# SERVICE BULLETIN

SERVICE BULLETIN NO: 30-001

## ICE AND RAIN PROTECTION - PITOT-STATIC AND AOA ANTI-ICE SYSTEM STATIC-PORT HEATER WIRES - INSPECTION

Inspection  
Figure 1

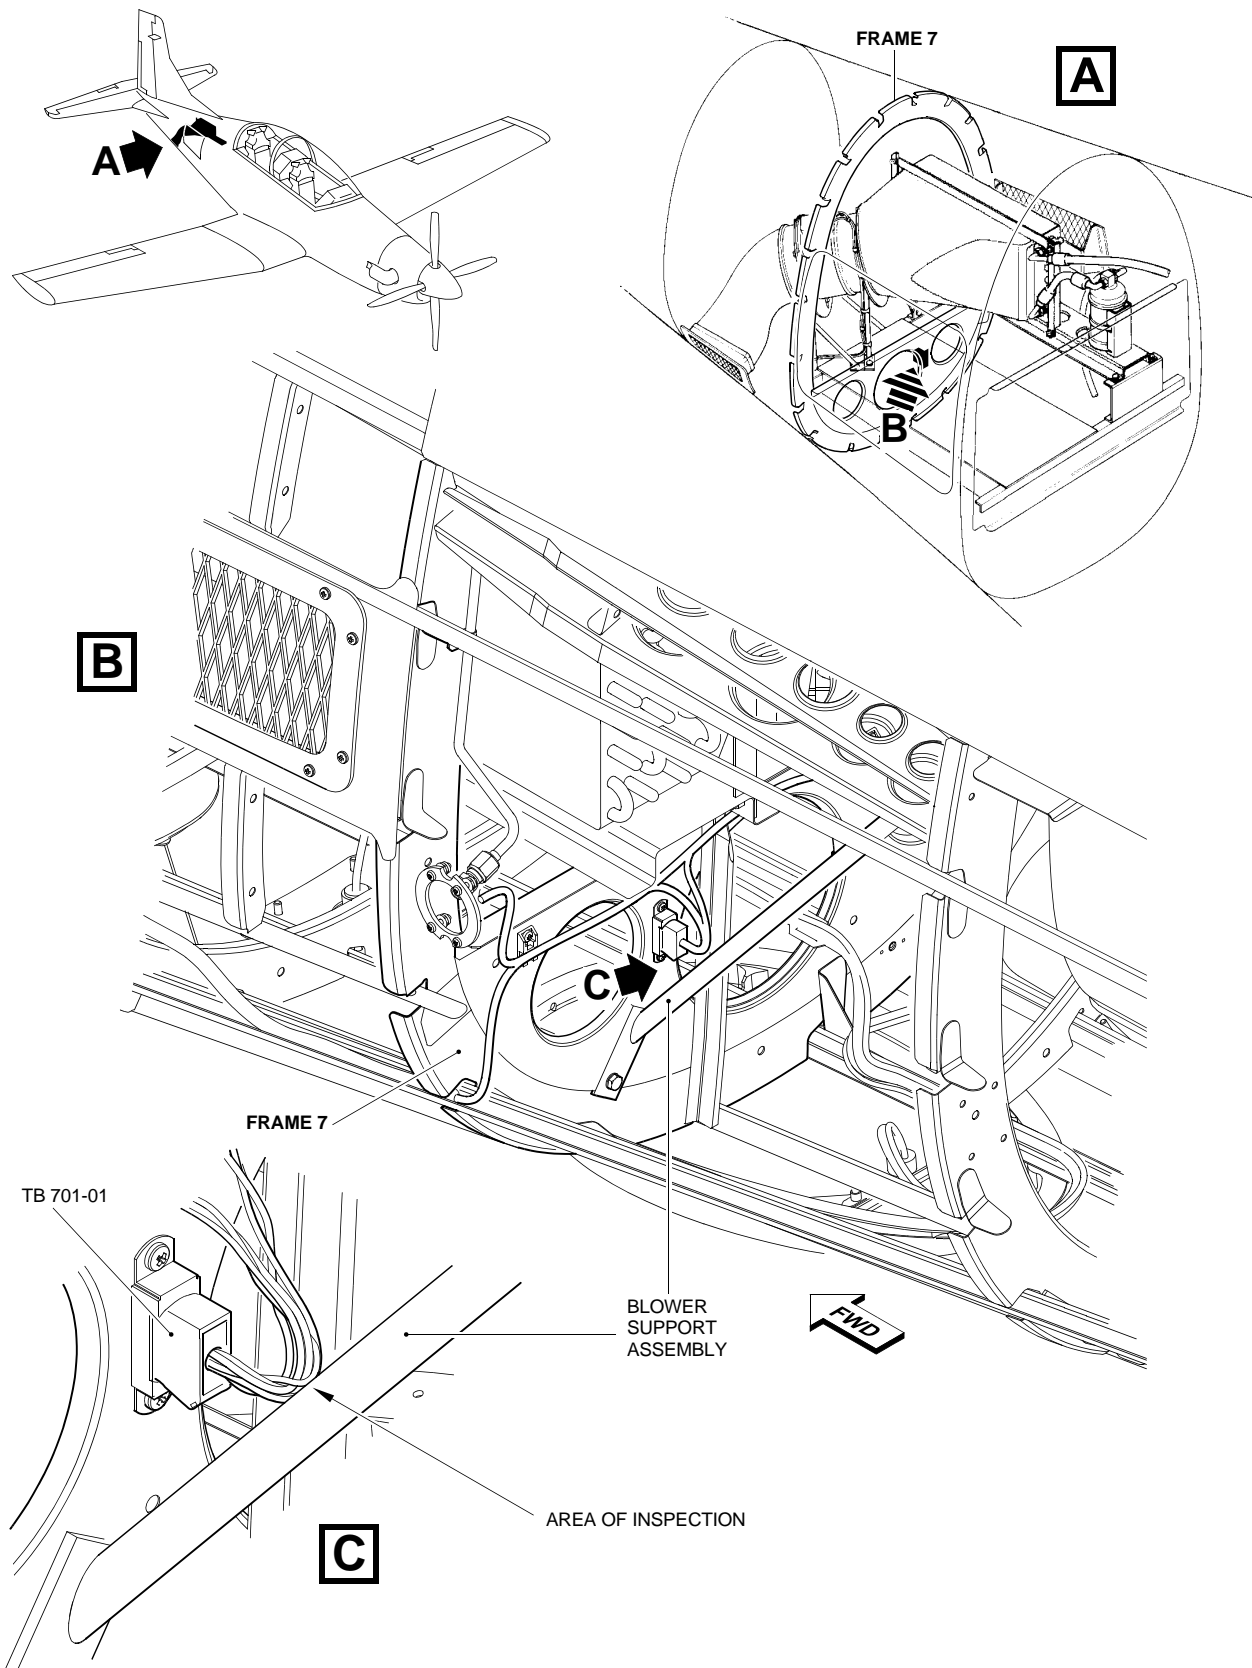
An operator has reported a failure of the static-port heating.

Chafing of electrical wires against a support strut for the condenser fan.

- (1) Examine the wires connected to TB701-01 to see if they can touch the support-strut for the condenser blower motor:

Do an inspection of the wires to make sure they are not damaged and do not chafe against the support strut.

(a) If the wires do not touch the strut, and you cannot move them to make them touch, no further action is necessary. Continue the procedure at Para. C. Test.

(b) If the wires touch the strut, or if you can move them to make them touch:

(i) Use a bright light source and X10 magnifier to examine the wires for chafing or burning.

(ii) If you find signs of melting, burning or the insulation is worn so that you can see the metal wire inside, you must replace the wire(s). Obey the safety precautions given in AMM 24-00-00, Page Block 201.

(iii) Apply glass-fiber tape (Material No. P09-020) around the support-strut where the wires can touch.

(iv) If possible, attach the wires to the support-strut with cable ties (Material No. P09-008) to prevent movement. Do not do this if it puts strain on the wires.
